HENDERSONVILLE ZONING - LEGEND / NOTES

**isomham**  
DESIGN GROUP PA  
Architecture - Planning  
1309 Collegiate Drive Wileysburg, NC 28687 www.isomham.com

tru by HILTON

FLAT ROCK  
SHEET  
A200

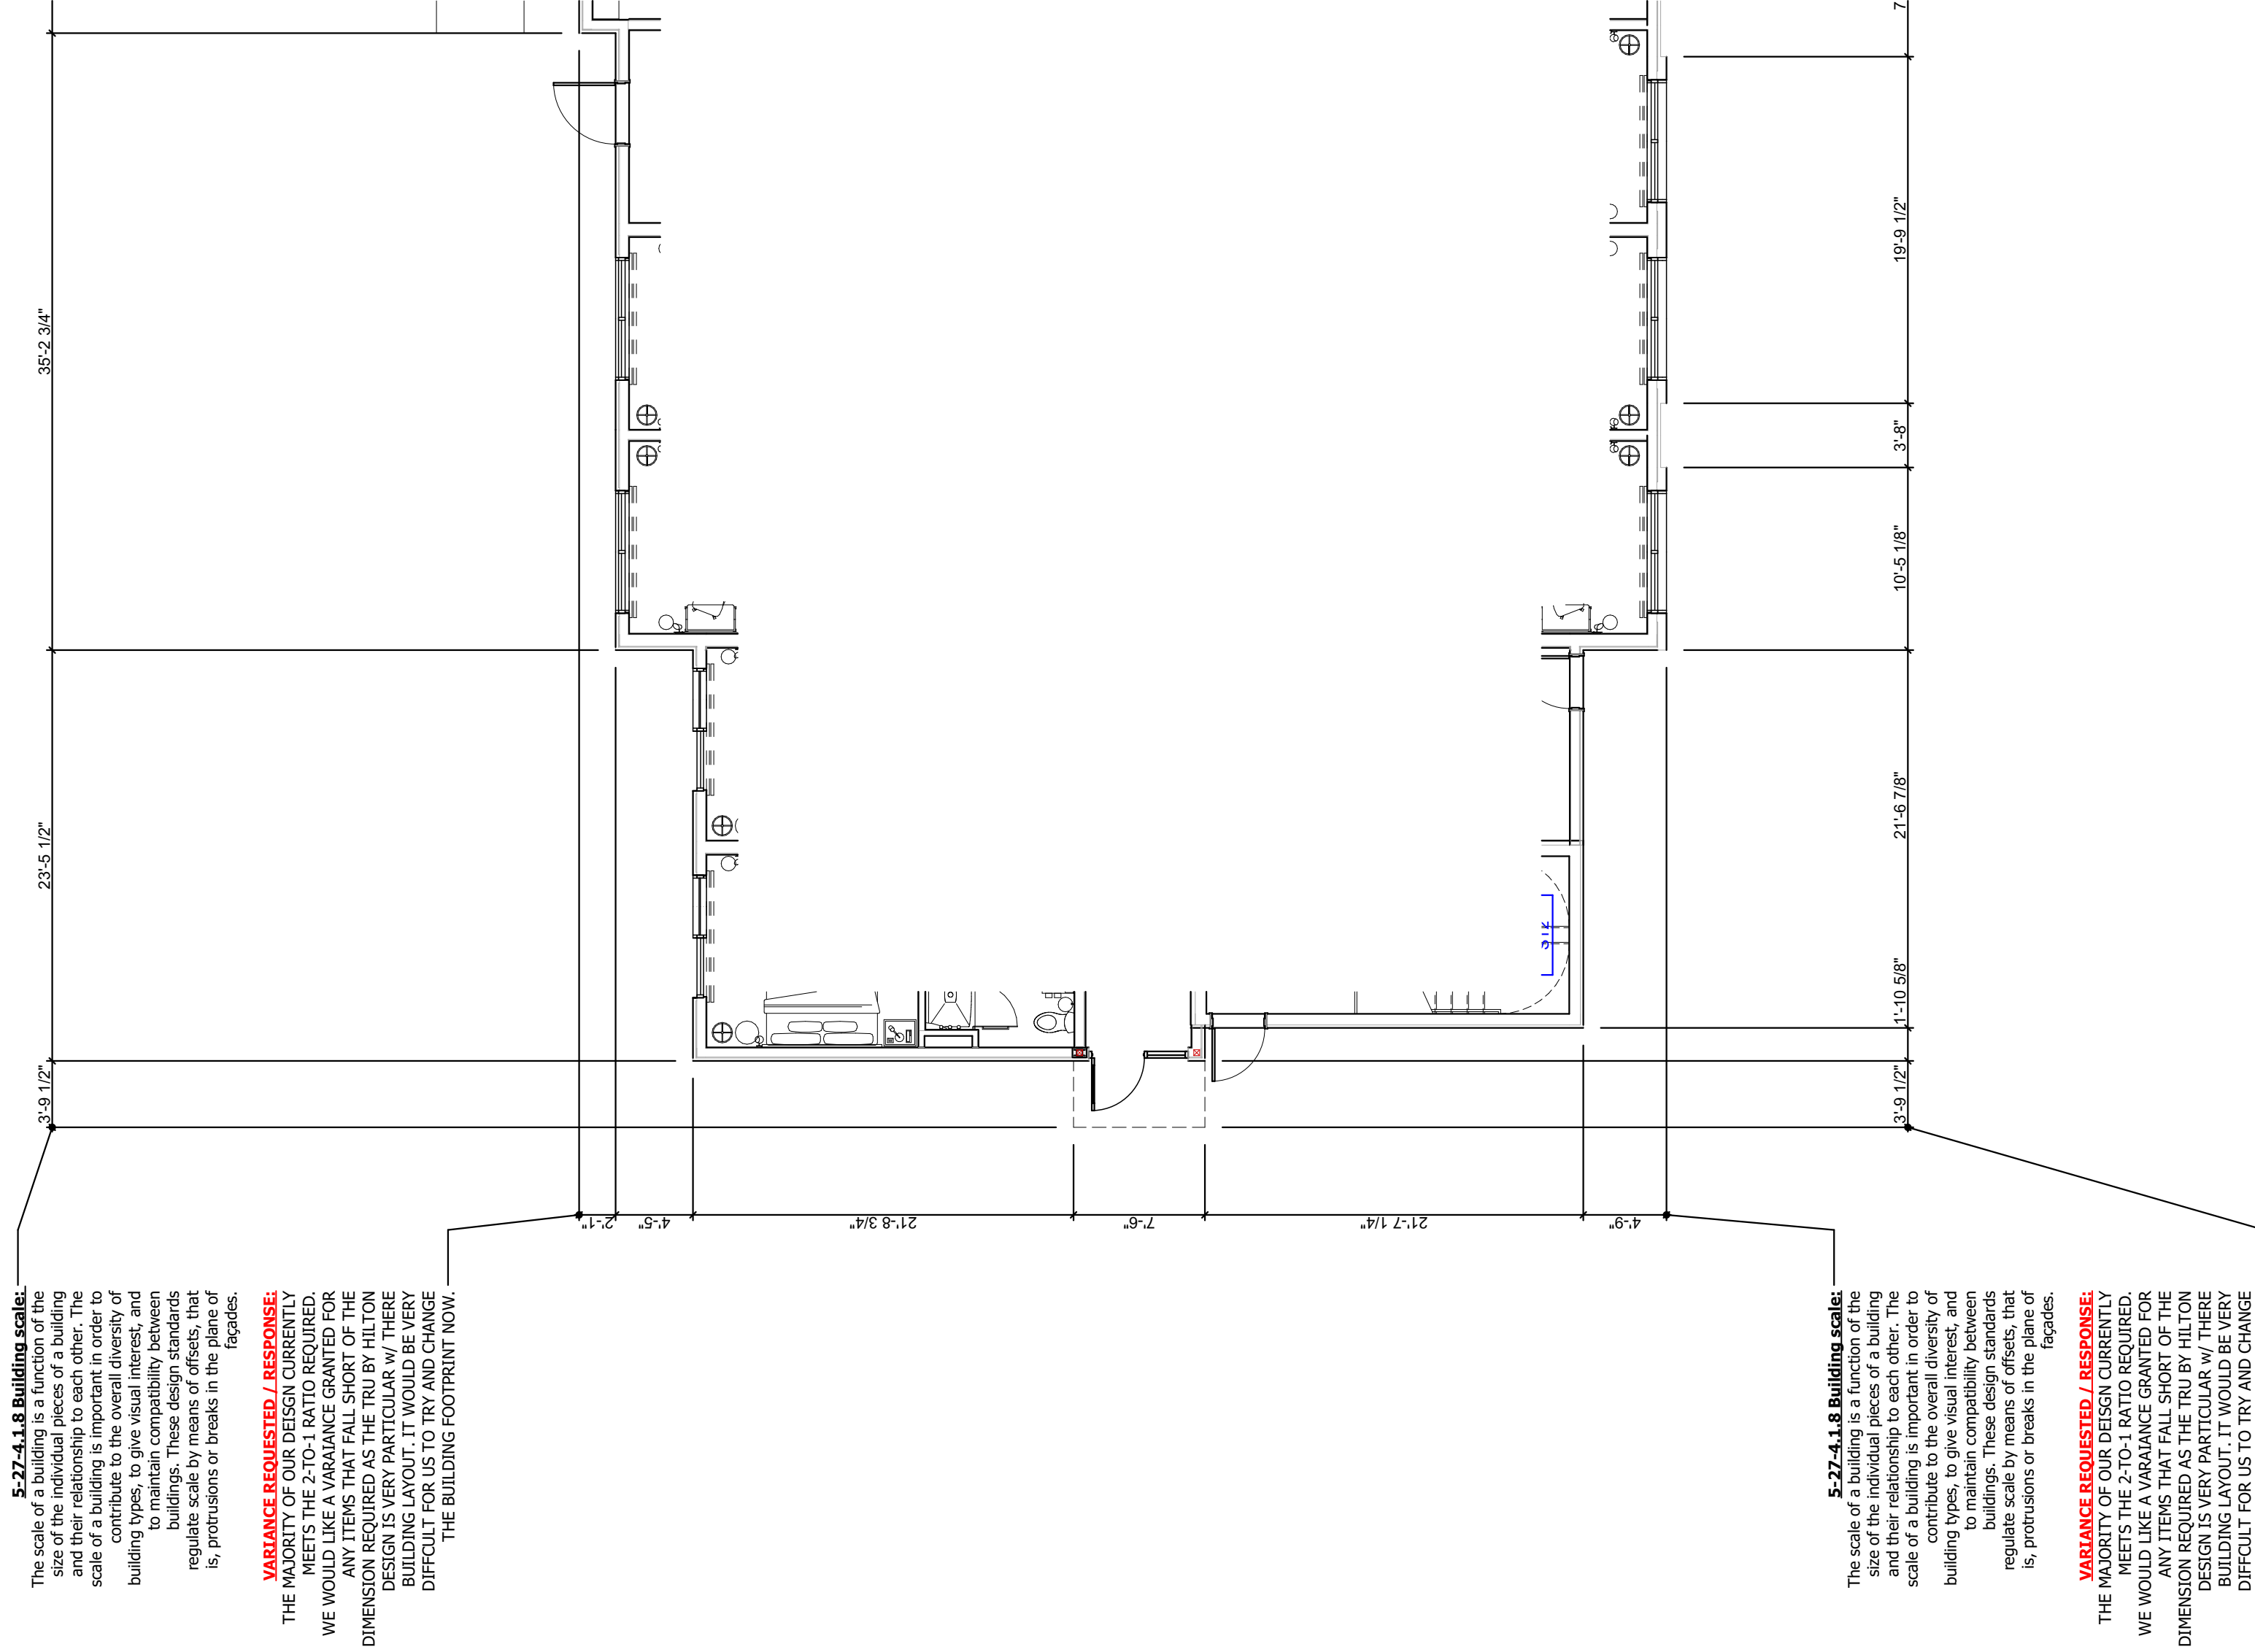
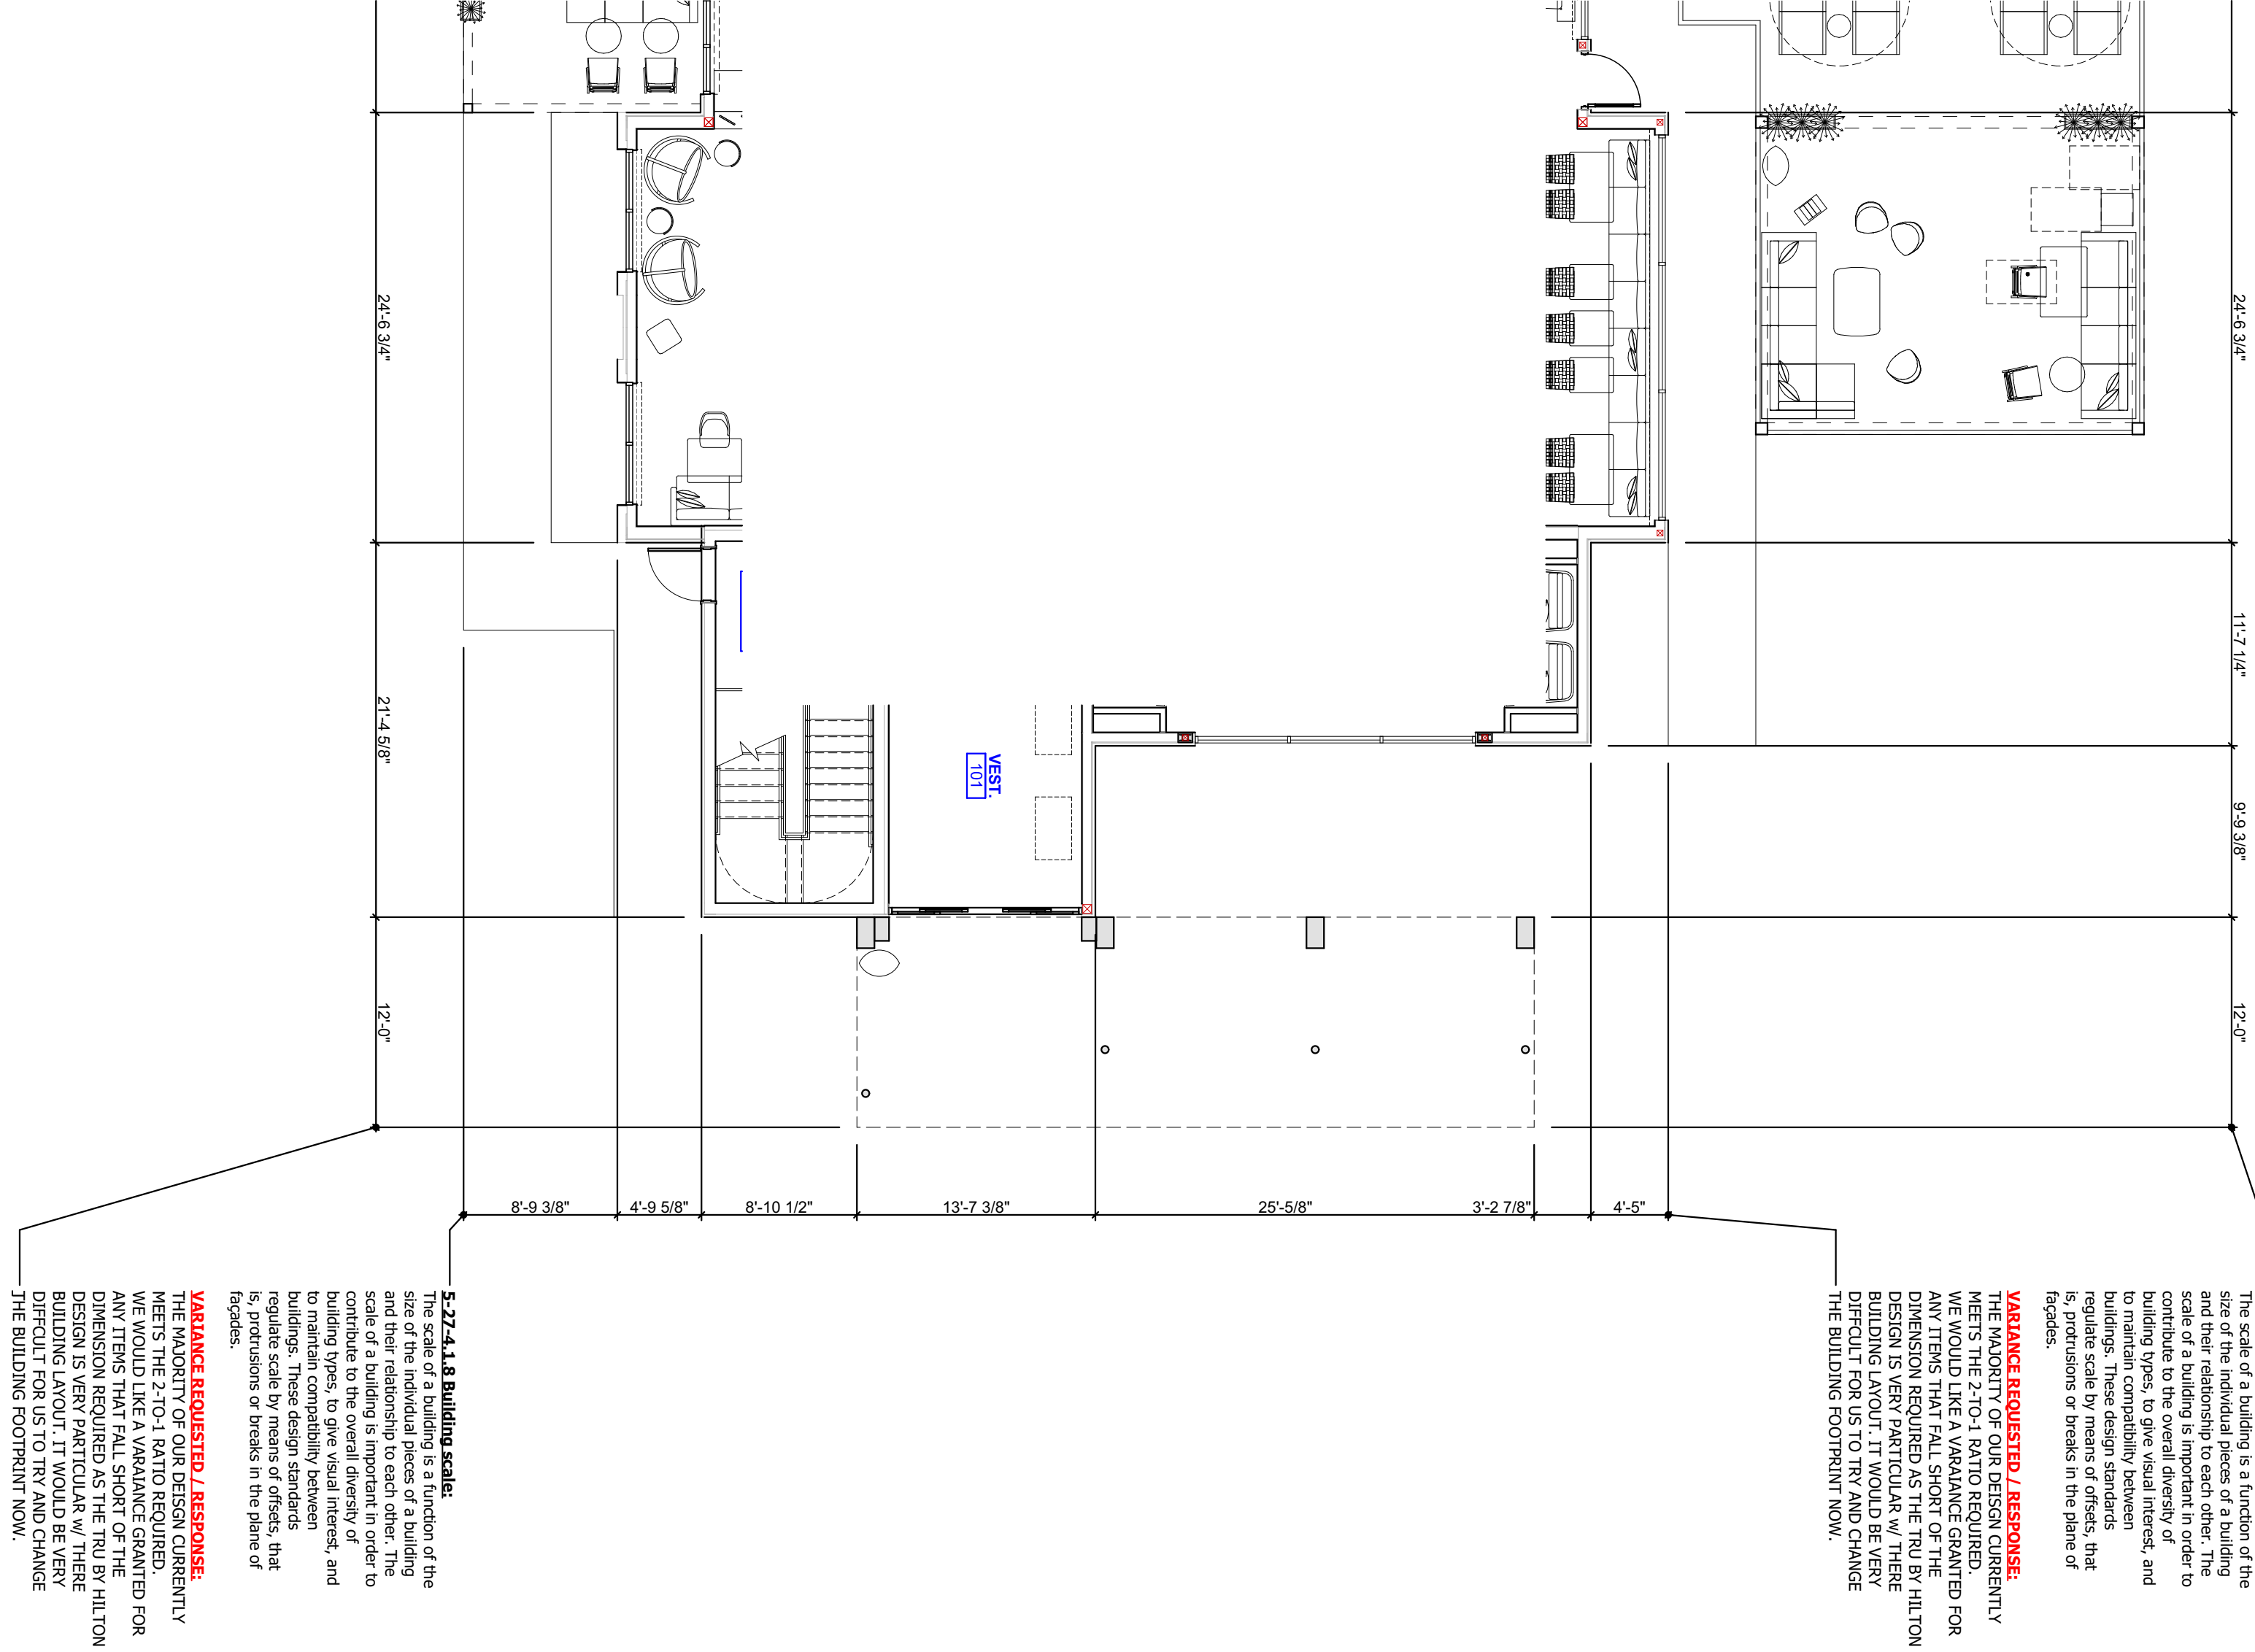
**5-27-4.1.8 Building scale:**  
The scale of a building is a function of the size of the individual pieces of a building and their relationship to each other. The scale of a building is important in order to contribute to the overall diversity of building types, to give visual interest, and to maintain compatibility between buildings. These design standards regulate scale by means of offsets, that is, protrusions or breaks in the plane of facades.

**5-27-4.3.4 Roofs:**  
Parapets and decorative cornices are required for buildings with a flat roof.

**5-27-4.1.7 Windows:**  
Windows shall either be (1) recessed a minimum of three inches from the facade or (2) trimmed. If trim is used, it shall be a minimum of four inches (nominal) in width and shall project beyond the facade.

**5-27-4.1.8 Building scale:**  
The scale of a building is a function of the size of the individual pieces of a building and their relationship to each other. The scale of a building is important in order to contribute to the overall diversity of building types, to give visual interest, and to maintain compatibility between buildings. These design standards regulate scale by means of offsets, that is, protrusions or breaks in the plane of facades.

**All buildings shall provide:**  
Detailed design along all facades which are visible from a street or common space. Detailed design shall be provided by using at least 3 architectural features. Please call out which features you plan to utilize.

**5-27-4.1.6 Building facades:**  
Front, rear and side facades of buildings shall contain at least two building materials which shall contrast in color and texture. At least 15 percent of the facade, exclusive of windows, doors and trim, shall consist of stone, brick, decorative concrete or decorative block.

**5-27-4.1.6 Building facades:**  
Front, rear and side facades of buildings shall contain at least two building materials which shall contrast in color and texture. At least 15 percent of the facade, exclusive of windows, doors and trim, shall consist of stone, brick, decorative concrete or decorative block.

**5-27-4.1.8 Building scale:**  
The scale of a building is a function of the size of the individual pieces of a building and their relationship to each other. The scale of a building is important in order to contribute to the overall diversity of building types, to give visual interest, and to maintain compatibility between buildings. These design standards regulate scale by means of offsets, that is, protrusions or breaks in the plane of facades.

**All buildings shall provide:**  
Detailed design along all facades which are visible from a street or common space. Detailed design shall be provided by using at least 3 architectural features. Please call out which features you plan to utilize.

**5-27-4.1.6 Building facades:**  
Front, rear and side facades of buildings shall contain at least two building materials which shall contrast in color and texture. At least 15 percent of the facade, exclusive of windows, doors and trim, shall consist of stone, brick, decorative concrete or decorative block.

**5-27-4.1.6 Building facades:**  
Front, rear and side facades of buildings shall contain at least two building materials which shall contrast in color and texture. At least 15 percent of the facade, exclusive of windows, doors and trim, shall consist of stone, brick, decorative concrete or decorative block.

**5-27-4.3.4 Roofs:**  
Parapets and decorative cornices are required for buildings with a flat roof.

**5-27-4.1.7 Windows:**  
Windows shall either be (1) recessed a minimum of three inches from the facade or (2) trimmed. If trim is used, it shall be a minimum of four inches (nominal) in width and shall project beyond the facade.

**5-27-4.1.8 Building scale:**  
The scale of a building is a function of the size of the individual pieces of a building and their relationship to each other. The scale of a building is important in order to contribute to the overall diversity of building types, to give visual interest, and to maintain compatibility between buildings. These design standards regulate scale by means of offsets, that is, protrusions or breaks in the plane of facades.

**All buildings shall provide:**  
Detailed design along all facades which are visible from a street or common space. Detailed design shall be provided by using at least 3 architectural features. Please call out which features you plan to utilize.

**5-27-4.1.6 Building facades:**  
Front, rear and side facades of buildings shall contain at least two building materials which shall contrast in color and texture. At least 15 percent of the facade, exclusive of windows, doors and trim, shall consist of stone, brick, decorative concrete or decorative block.

**All buildings shall provide:**  
Detailed design along all facades which are visible from a street or common space. Detailed design shall be provided by using at least 3 architectural features. Please call out which features you plan to utilize.

**5-27-4.1.6 Building facades:**  
Front, rear and side facades of buildings shall contain at least two building materials which shall contrast in color and texture. At least 15 percent of the facade, exclusive of windows, doors and trim, shall consist of stone, brick, decorative concrete or decorative block.

**VARIANCE REQUESTED / RESPONSE:**  
THE MAJORITY OF OUR DESIGN CURRENTLY MEETS THE 2-TO-1 RATIO REQUIRED. WE WOULD LIKE A VARIANCE GRANTED FOR ANY ITEMS THAT FALL SHORT OF THE DIMENSION REQUIRED AS THE TRU BY HILTON DESIGN IS VERY PARTICULAR W/ THERE BUILDING LAYOUT. IT WOULD BE VERY DIFFICULT FOR US TO TRY AND CHANGE THE BUILDING FOOTPRINT NOW.

**VARIANCE REQUESTED / RESPONSE:**  
TRU BY HILTON REQUIREMENTS DO NOT ALLOW CORNICE CHANGES. WE HAVE PARAPETS FOR THE ENTIRE ROOF... THE DESIGN OF THEM MUST STAY SPECIFIC TO HILTON REQS.

**RESPONSE:**  
WE WILL RECESS WINDOWS 3". REVISED SECTIONS WILL FOLLOW.

**RESPONSE:**  
WE HAVE REPLACED THE CLEAR ANODIZED ALUMINUM WINDOWS W/ DARK BRONZE FINISH.

**VARIANCE REQUESTED / RESPONSE:**  
THE MAJORITY OF OUR DESIGN CURRENTLY MEETS THE 2-TO-1 RATIO REQUIRED. WE WOULD LIKE A VARIANCE GRANTED FOR ANY ITEMS THAT FALL SHORT OF THE DIMENSION REQUIRED AS THE TRU BY HILTON DESIGN IS VERY PARTICULAR W/ THERE BUILDING LAYOUT. IT WOULD BE VERY DIFFICULT FOR US TO TRY AND CHANGE THE BUILDING FOOTPRINT NOW.

**RESPONSE:**  
ARCHITECTURAL FEATURE BUILDING OFFSETS PROVIDED.

**VARIANCE REQUESTED / RESPONSE:**  
TRU BY HILTON REQUIREMENTS DO NOT ALLOW MATERIAL CHANGES. WE BELIEVE WE ARE MEETING THIS CRITERIA AS MUCH AS POSSIBLE. THIS COLOR (DRYVIT SYSTEMS: #61B8 OVERCAST) WILL BE APPLIED USING SANDBLAST FINISH.

**VARIANCE REQUESTED / RESPONSE:**  
TRU BY HILTON REQUIREMENTS DO NOT ALLOW MATERIAL CHANGES. WE BELIEVE WE ARE MEETING THIS CRITERIA AS MUCH AS POSSIBLE. THIS COLOR (DRYVIT SYSTEMS: PANTONE 7C BLACK) WILL BE APPLIED USING DEMANDIT SMOOTH FINISH.

**VARIANCE REQUESTED / RESPONSE:**  
THE MAJORITY OF OUR DESIGN CURRENTLY MEETS THE 2-TO-1 RATIO REQUIRED. WE WOULD LIKE A VARIANCE GRANTED FOR ANY ITEMS THAT FALL SHORT OF THE DIMENSION REQUIRED AS THE TRU BY HILTON DESIGN IS VERY PARTICULAR W/ THERE BUILDING LAYOUT. IT WOULD BE VERY DIFFICULT FOR US TO TRY AND CHANGE THE BUILDING FOOTPRINT NOW.

**RESPONSE:**  
ARCHITECTURAL FEATURE BUILDING OFFSETS PROVIDED.

**VARIANCE REQUESTED / RESPONSE:**  
TRU BY HILTON REQUIREMENTS DO NOT ALLOW MATERIAL CHANGES. WE BELIEVE WE ARE MEETING THIS CRITERIA AS MUCH AS POSSIBLE. THIS COLOR (DRYVIT SYSTEMS: #61B8 OVERCAST) WILL BE APPLIED USING SANDBLAST FINISH.

**VARIANCE REQUESTED / RESPONSE:**  
TRU BY HILTON REQUIREMENTS DO NOT ALLOW MATERIAL CHANGES. WE BELIEVE WE ARE MEETING THIS CRITERIA AS MUCH AS POSSIBLE. THIS COLOR (DRYVIT SYSTEMS: PANTONE 7C BLACK) WILL BE APPLIED USING DEMANDIT SMOOTH FINISH.

**VARIANCE REQUESTED / RESPONSE:**  
TRU BY HILTON REQUIREMENTS DO NOT ALLOW CORNICE CHANGES. WE HAVE PARAPETS FOR THE ENTIRE ROOF... THE DESIGN OF THEM MUST STAY SPECIFIC TO HILTON REQS.

**RESPONSE:**  
WE WILL RECESS WINDOWS 3". REVISED SECTIONS WILL FOLLOW.

**RESPONSE:**  
WE HAVE REPLACED THE CLEAR ANODIZED ALUMINUM WINDOWS W/ DARK BRONZE FINISH.

**VARIANCE REQUESTED / RESPONSE:**  
THE MAJORITY OF OUR DESIGN CURRENTLY MEETS THE 2-TO-1 RATIO REQUIRED. WE WOULD LIKE A VARIANCE GRANTED FOR ANY ITEMS THAT FALL SHORT OF THE DIMENSION REQUIRED AS THE TRU BY HILTON DESIGN IS VERY PARTICULAR W/ THERE BUILDING LAYOUT. IT WOULD BE VERY DIFFICULT FOR US TO TRY AND CHANGE THE BUILDING FOOTPRINT NOW.

**RESPONSE:**  
ARCHITECTURAL FEATURE BUILDING OFFSETS PROVIDED.

**VARIANCE REQUESTED / RESPONSE:**  
TRU BY HILTON REQUIREMENTS DO NOT ALLOW MATERIAL CHANGES. WE BELIEVE WE ARE MEETING THIS CRITERIA AS MUCH AS POSSIBLE. THIS COLOR (DRYVIT SYSTEMS: #207 GLACIER) WILL BE APPLIED USING TERRAZZO GRANITE FINISH.

**RESPONSE:**  
ARCHITECTURAL FEATURE COVERED ENTRY PROVIDED.

**VARIANCE REQUESTED / RESPONSE:**  
TRU BY HILTON REQUIREMENTS DO NOT ALLOW MATERIAL CHANGES. WE BELIEVE WE ARE MEETING THIS CRITERIA AS MUCH AS POSSIBLE. THIS COLOR (DRYVIT SYSTEMS: #615A TATTLETALE) WILL BE APPLIED USING SANDBLAST FINISH.
